AMENDED IN RED

SITE PLAN

CLIENT: C&K ASSOCIATION	DATE: AUG 09	JOB NO: MTB-05-CK2
PROJECT: CHILD CARE CENTRE ELM ST BLACKWATER 4717	SCALE: 1:200	SHEET NO: 1

PLANS AND DOCUMENTS
referred to in the ULDA
APPROVAL dated 4 / 4 / 11

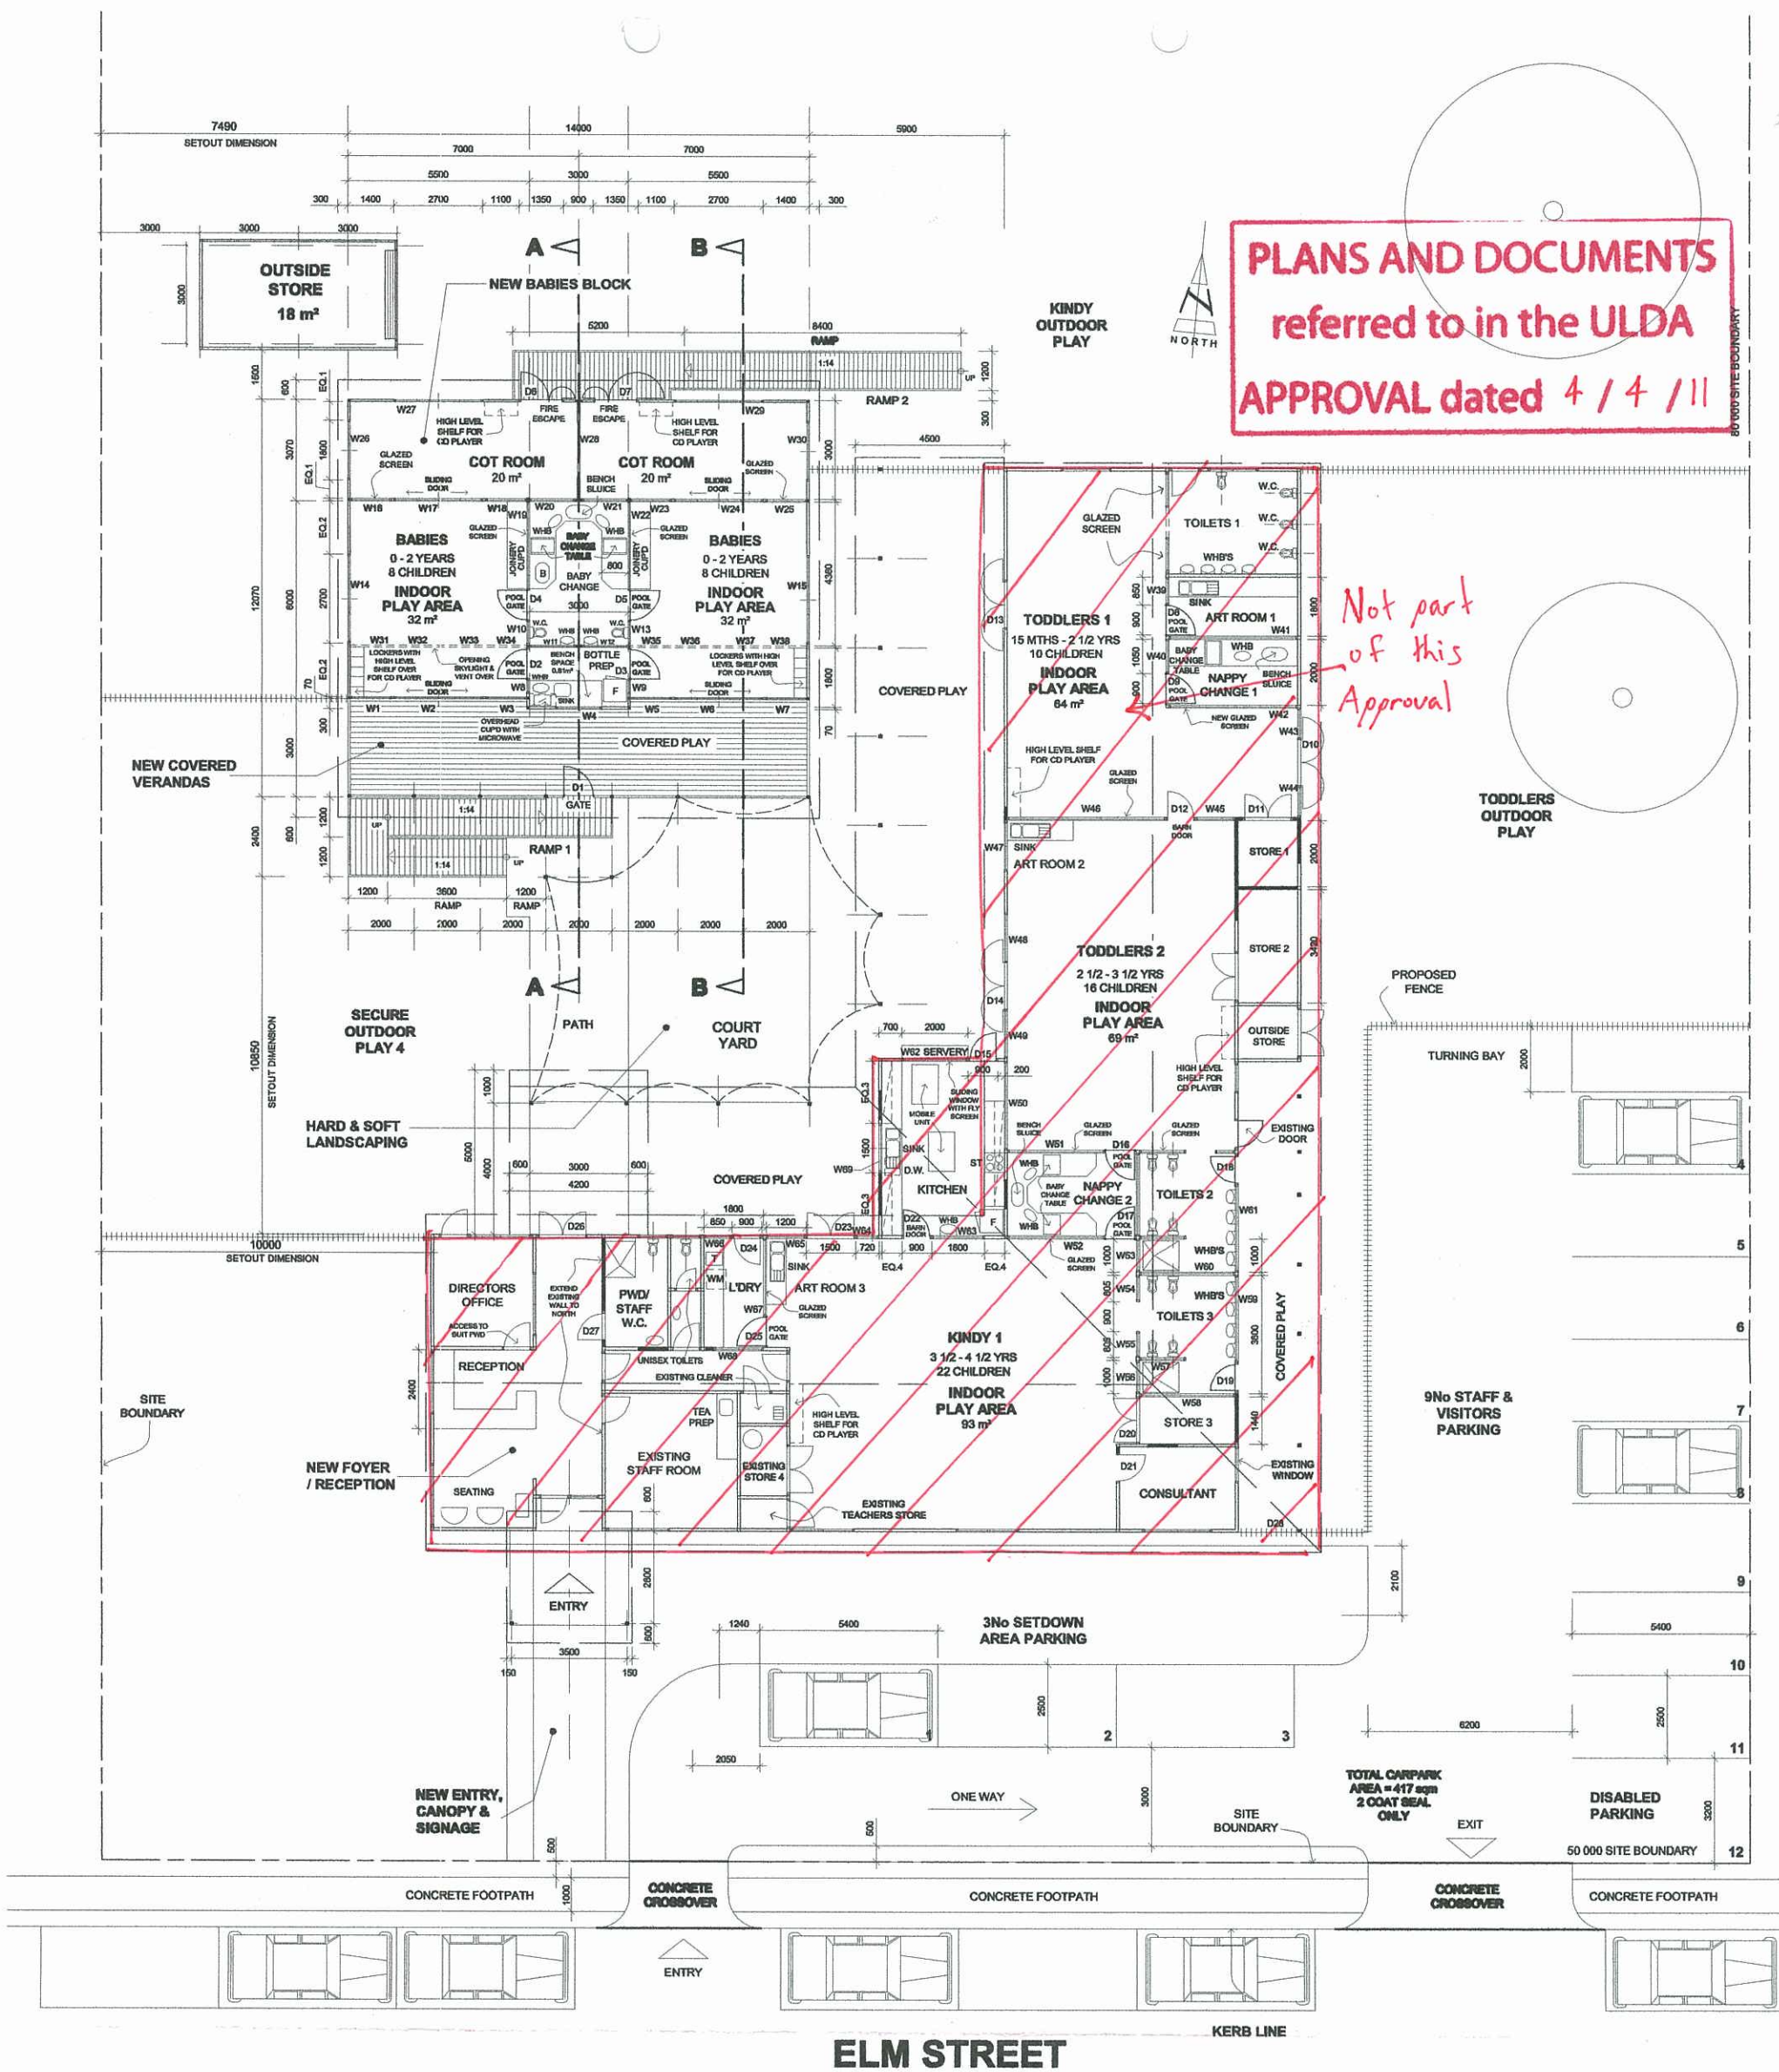
31 MAR 2011

By: Math Teon (name)
of the ULDA
